RE: TURN Comments Regarding the 2020 Wildfire Mitigation Plans

**TURN COMMENTS ON
2020 WILDFIRE MITIGATION PLANS**

Submitted to the Wildfire Safety Division

9
10 **Figure 2. Ignitions Due to Unhealthy vs. Healthy Trees Falling Over**
11 **PG&E Service Territory**

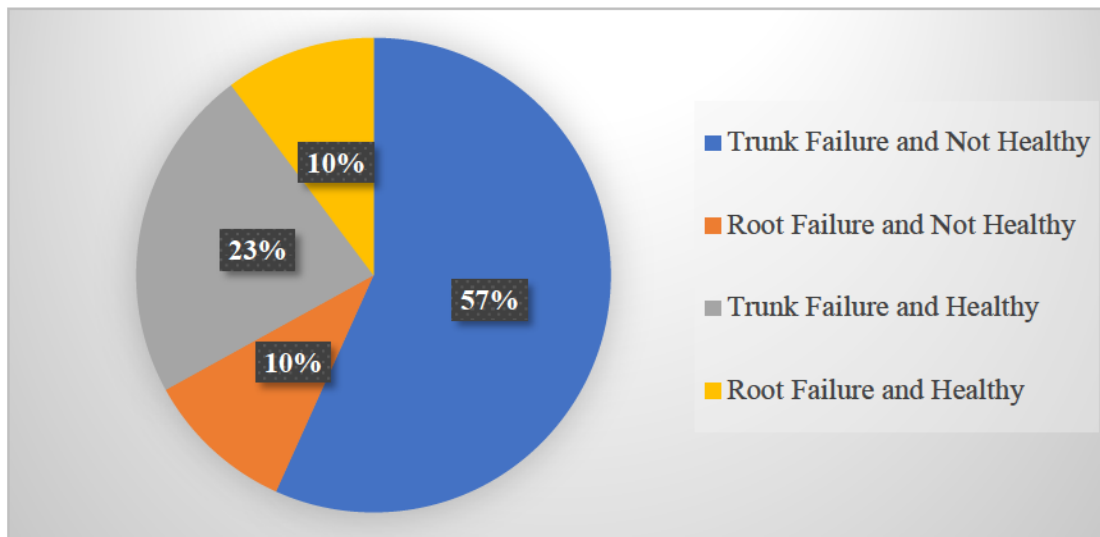
12 The impetus for PG&E’s program to remove this large number of trees is that the ten
13 targeted species “drive 75 percent of the vegetation-caused fire ignitions in Tier 2 and Tier 3
14 HFTD areas.”²⁹ This single data point is not persuasive as a valid basis for the mass removal of
15 living, healthy trees. It is important to note that sick and dying trees should already be removed
16 by PG&E under other programs.³⁰ Vegetation or branches from trees further away may require
17 greater pruning, but their removal is only necessary if a healthy tree has a high likelihood of
18 falling over during dry, windy conditions when a resultant ignition would be most likely to create
19 a high consequence wildfire. TURN recommends that the Commission 1) authorize only 10% of
20 the annual cost, a reduction of \$162 million in expenses, 2) require one-way balancing account
21 treatment, and 3) require an independent study to evaluate the need for healthy tree removal.
